ADDENDUM #1 Issued: January 6th, 2023

THE PURPOSE OF ADDENDUM IS TO <u>MAKE CHANGES</u>, AND P<u>ROVIDE ANSWERS TO THE REQUEST FOR</u> <u>CLARIFICATIONS</u> TO THE RFP DOCUMENTS.

Client/Project MONTGOMERY COLLEGE GERMANTOWN CAMPUS OBSERVATION DRIVE SIGN

ROADSIDE TREE PLAN

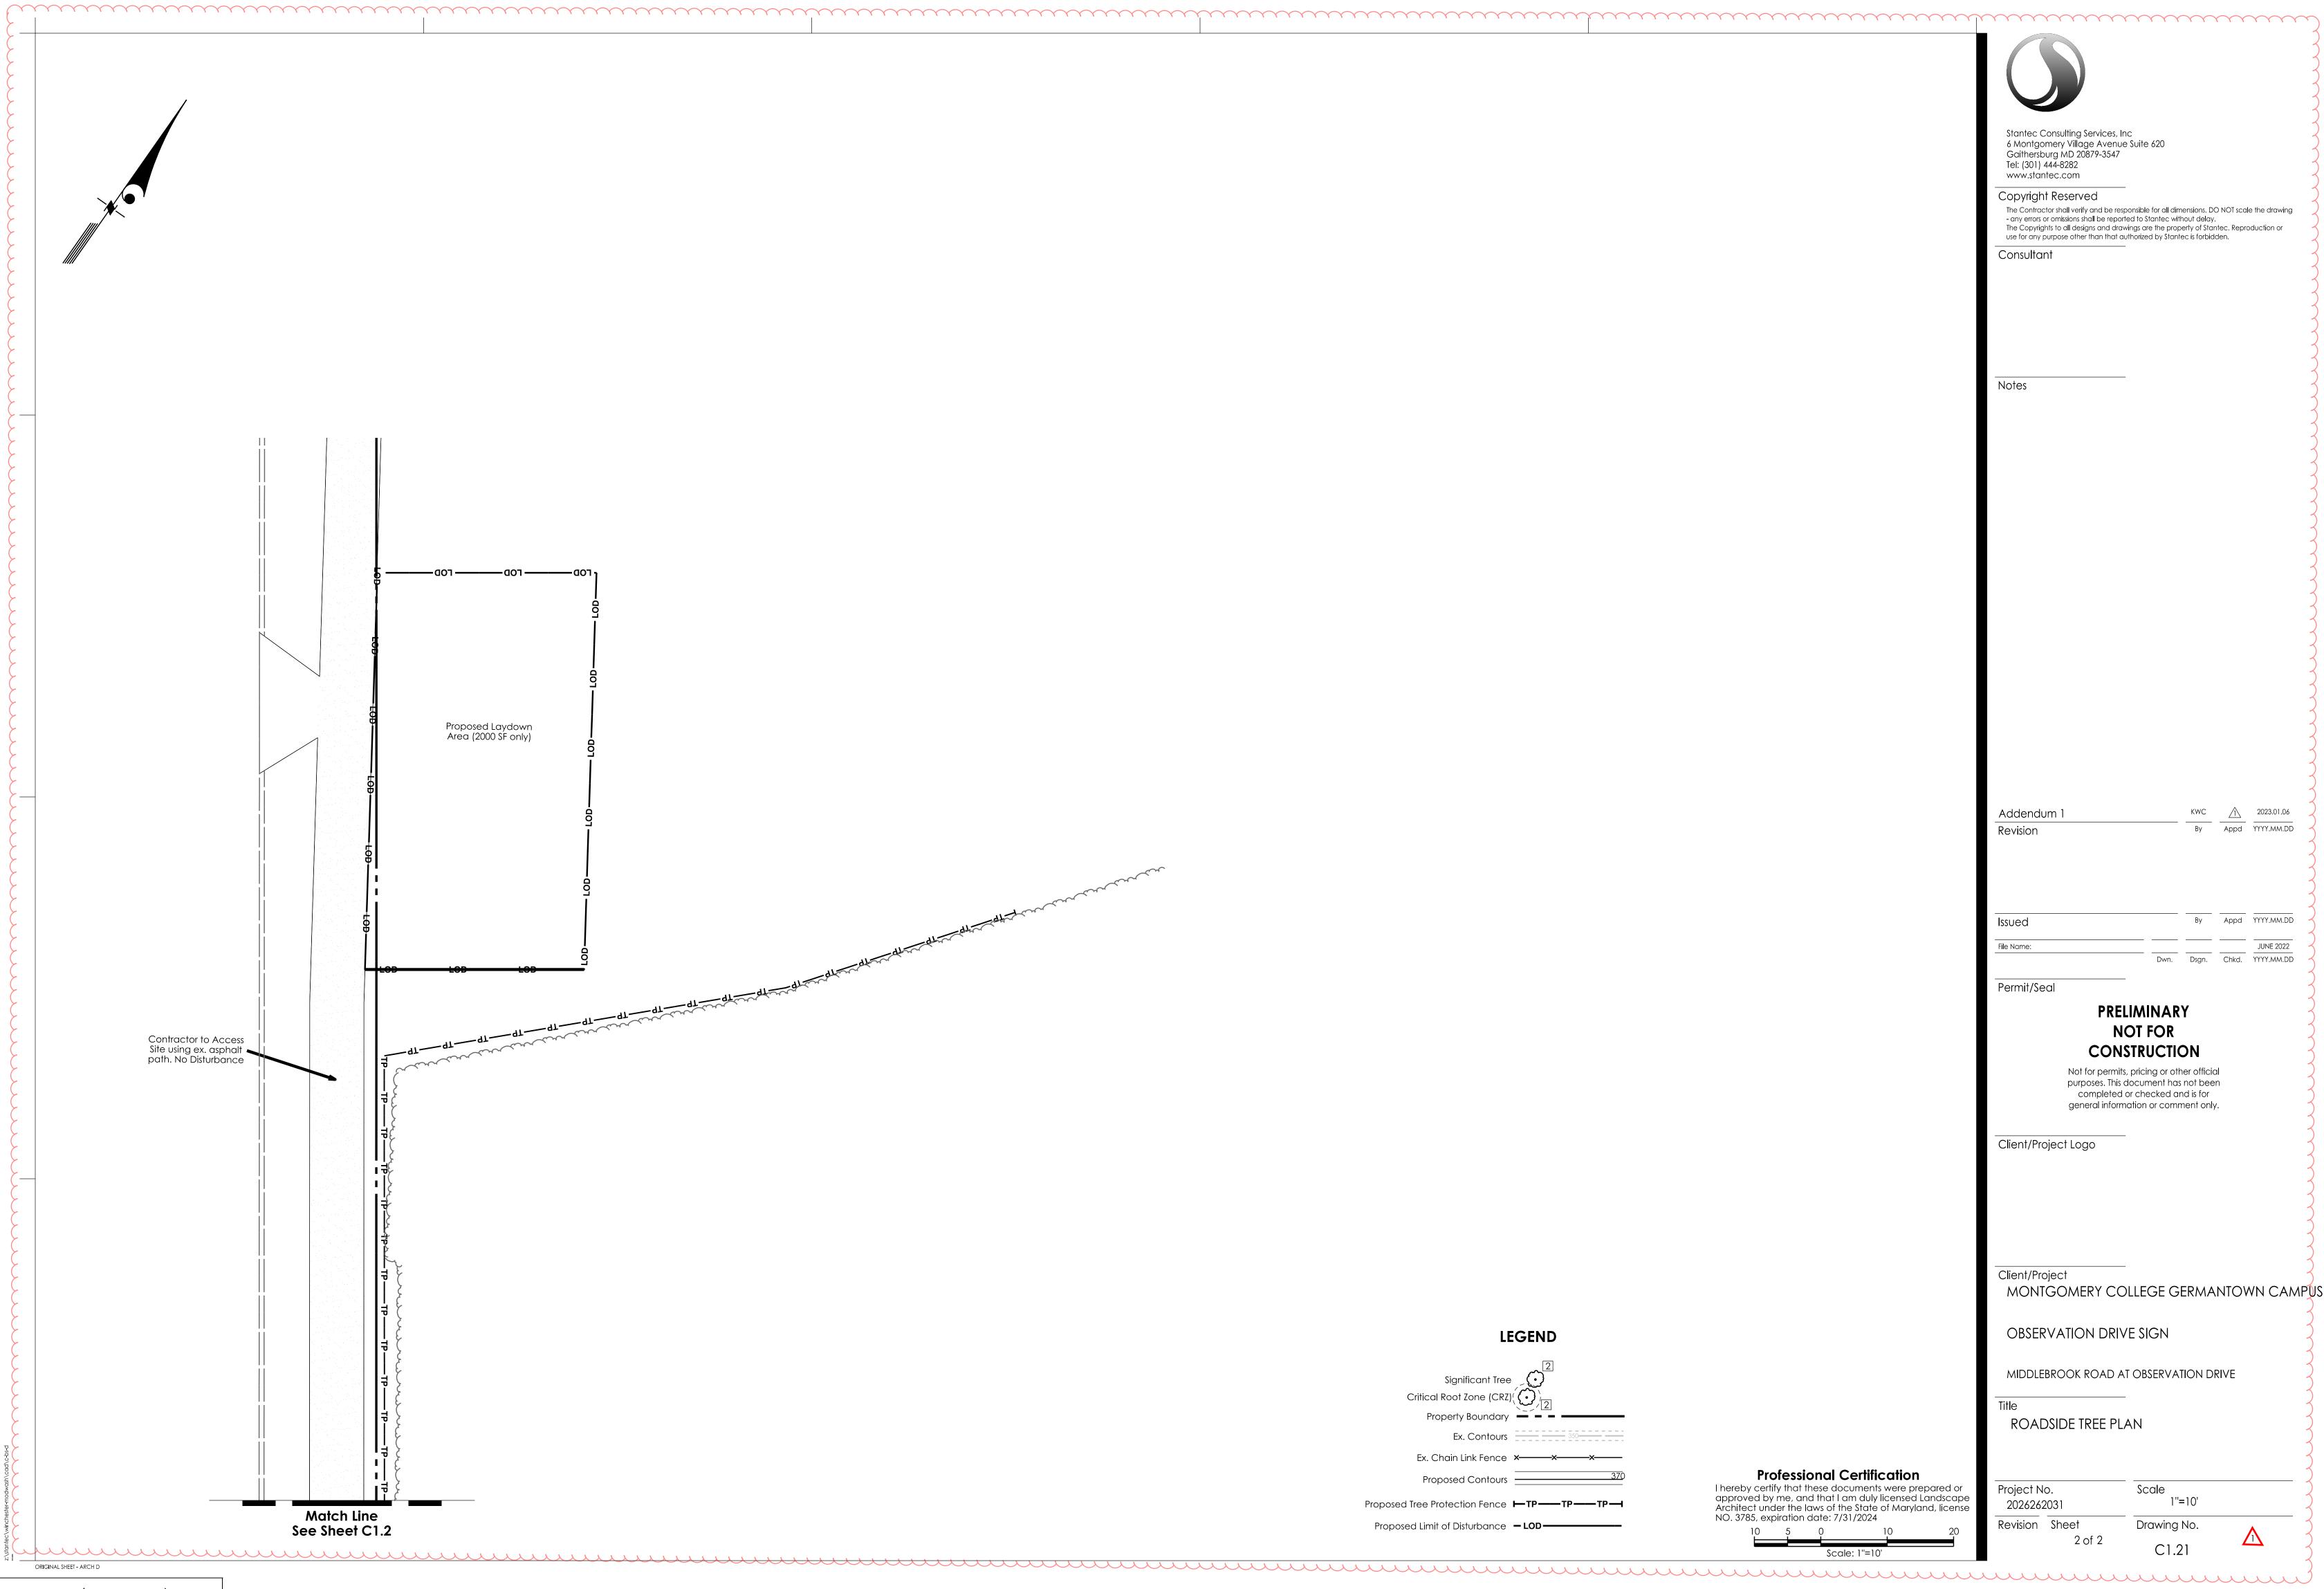
C1.2 – Drawing Limits, Limit-of-Disturbance (LOD), and Tree Protection Fencing (TP) revised to show extended project limits north along Observation Drive.

ROADSIDE TREE PLAN

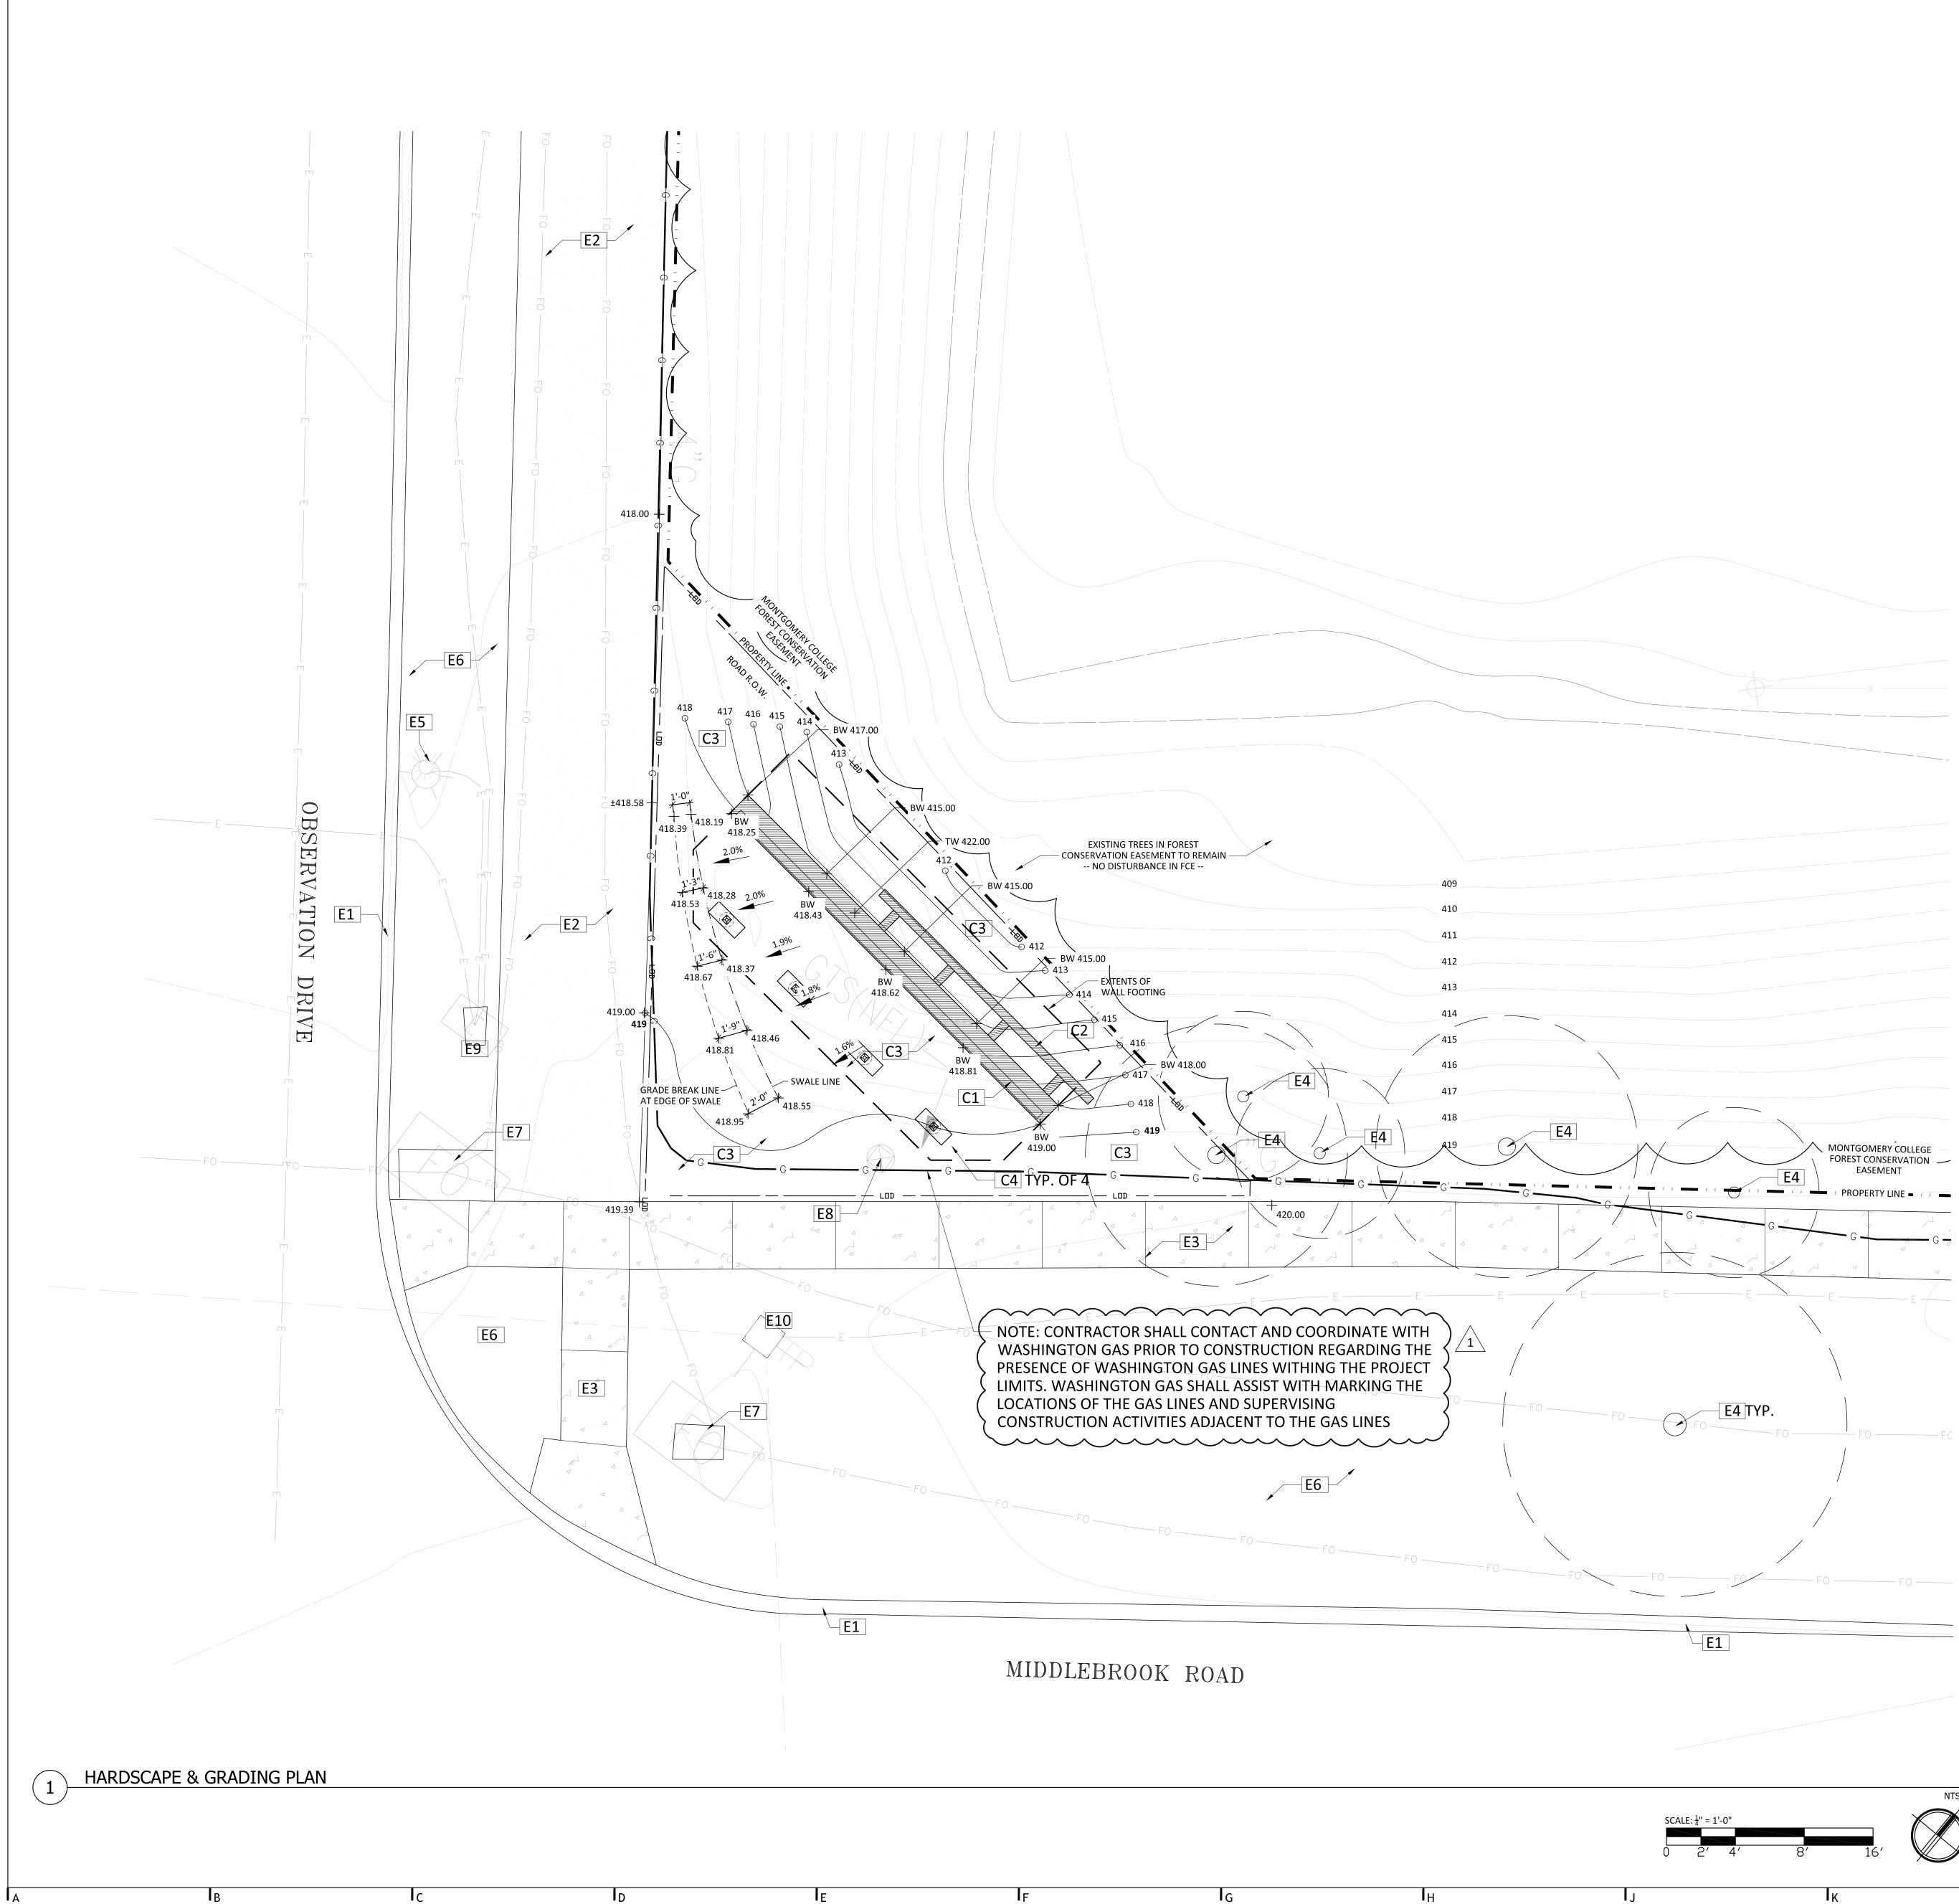
C1.21 – <u>*NEW SHEET*</u> Additional Roadside Tree Plan added to show extended project limits north along Observation Drive.

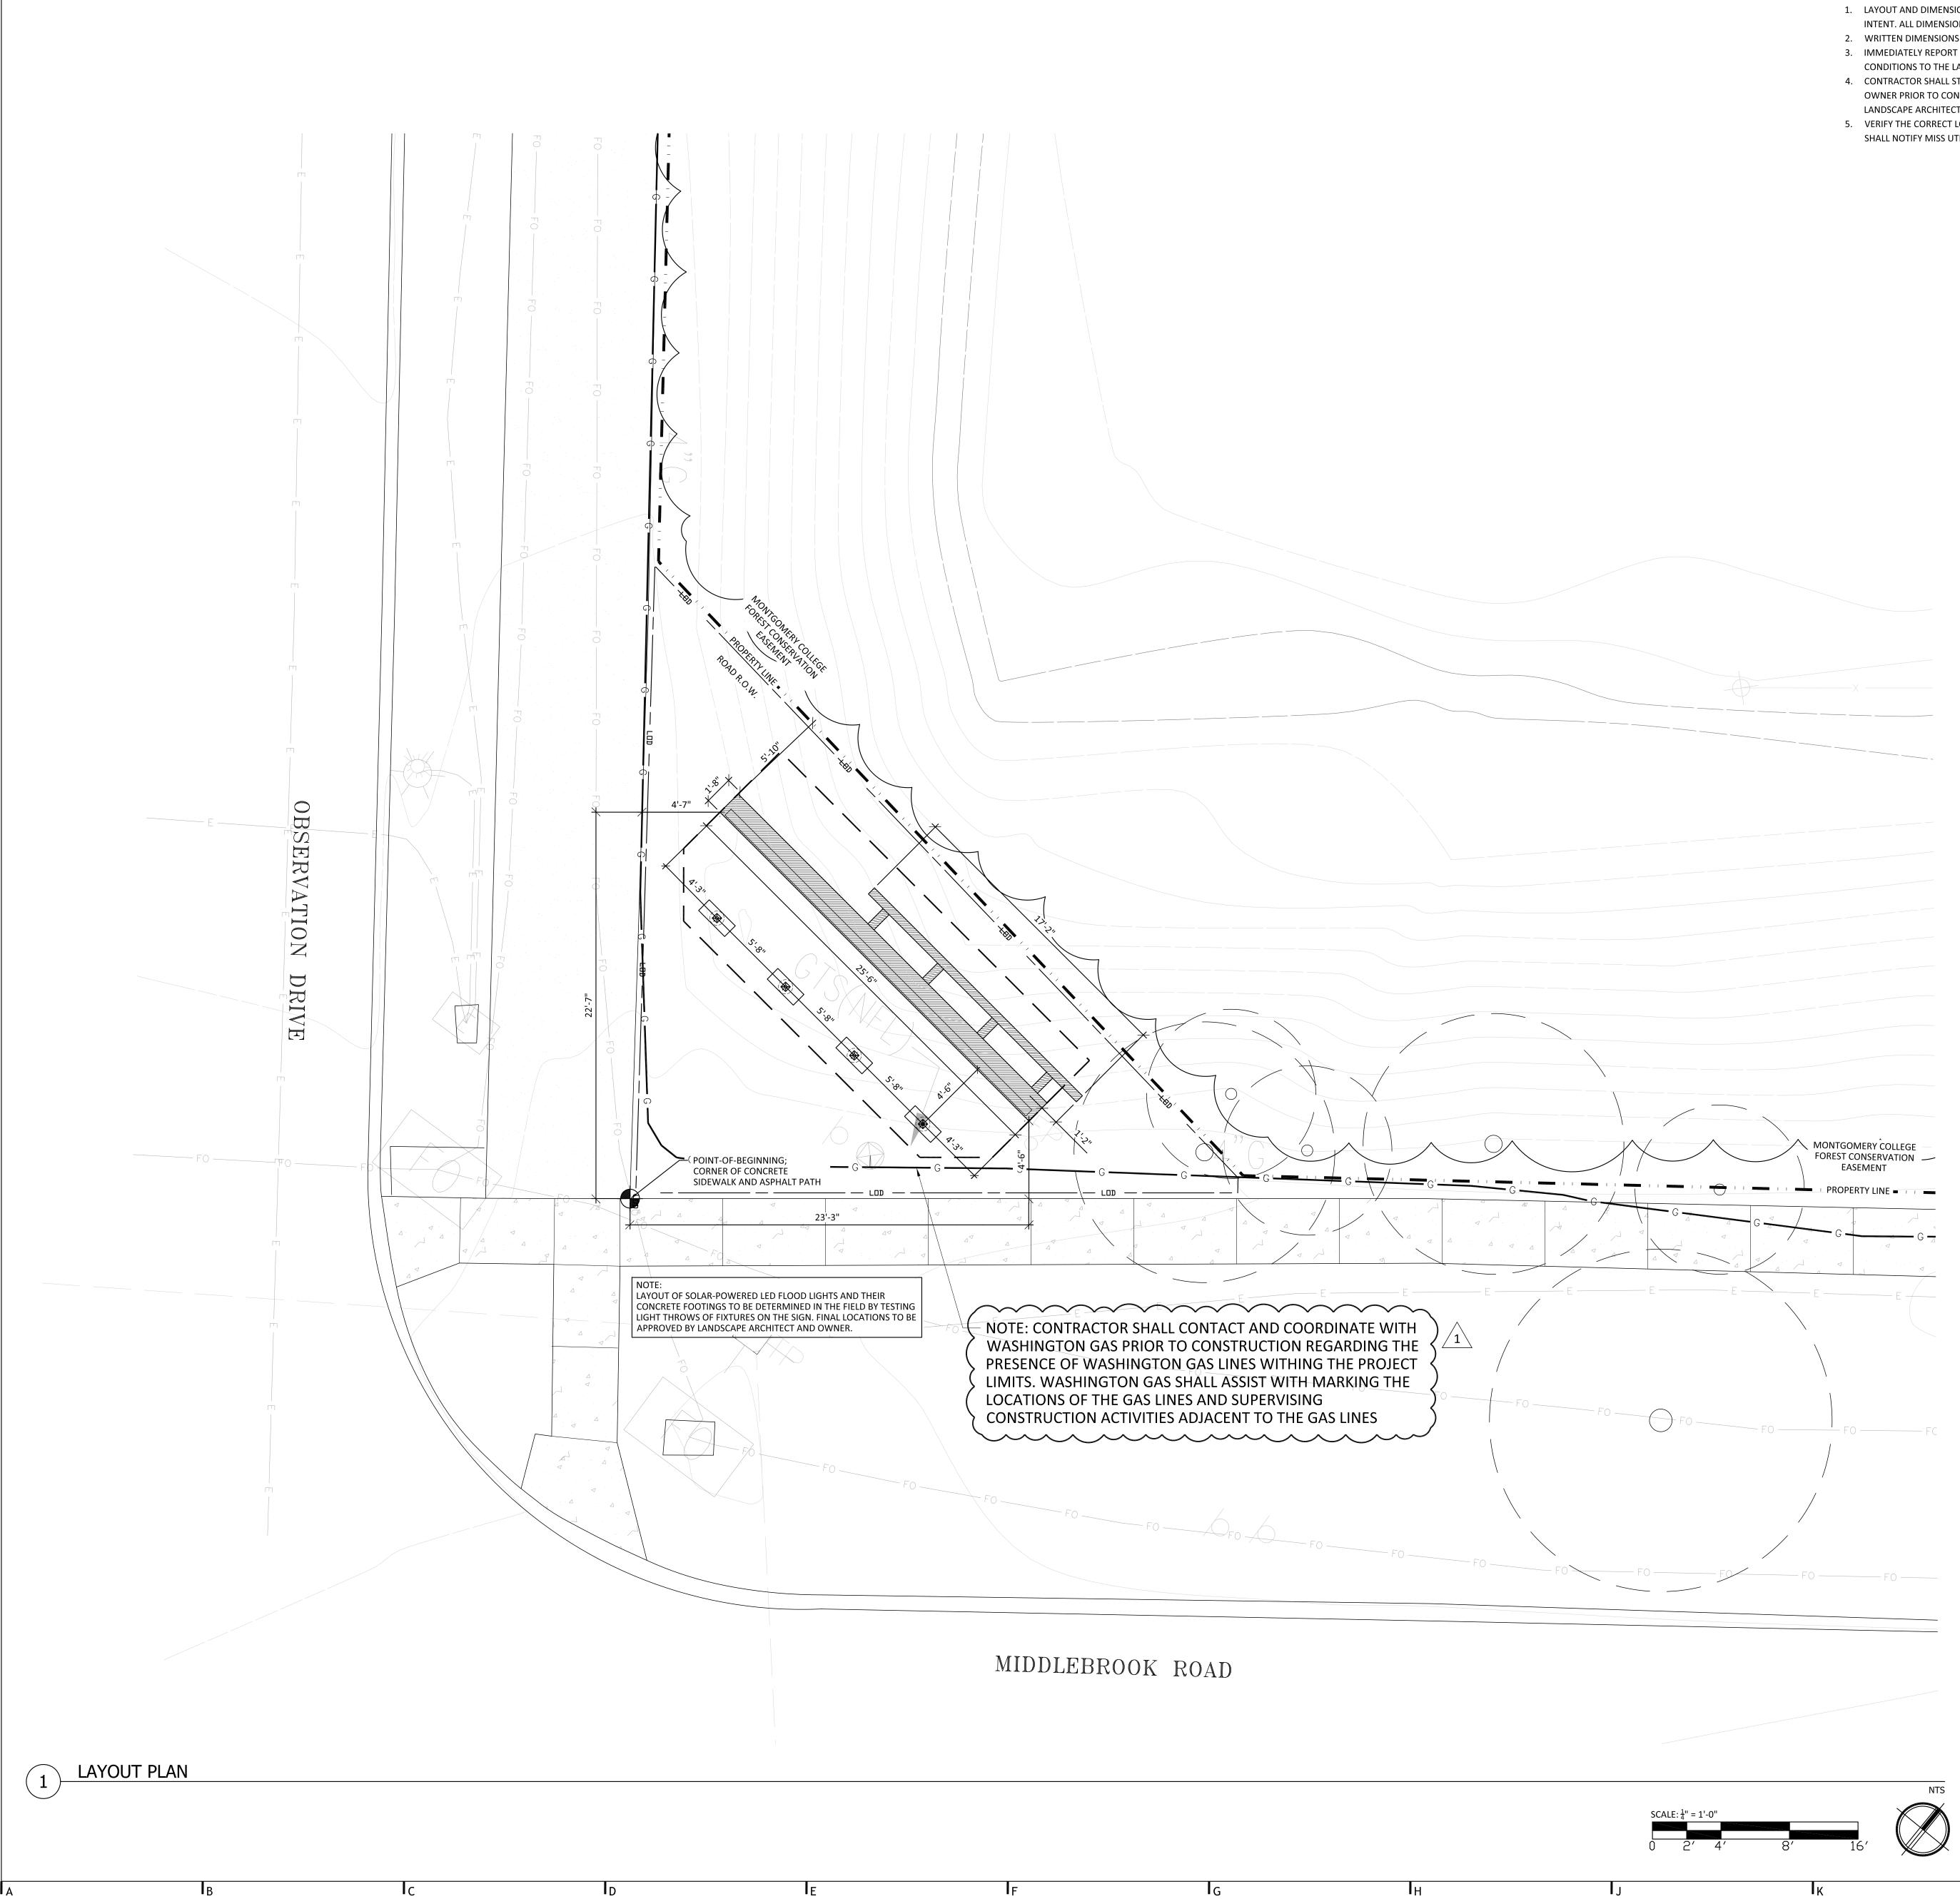
L1.0 – Note added regarding coordination with Washington Gas due to the presence of existing gas lines within the project limits.
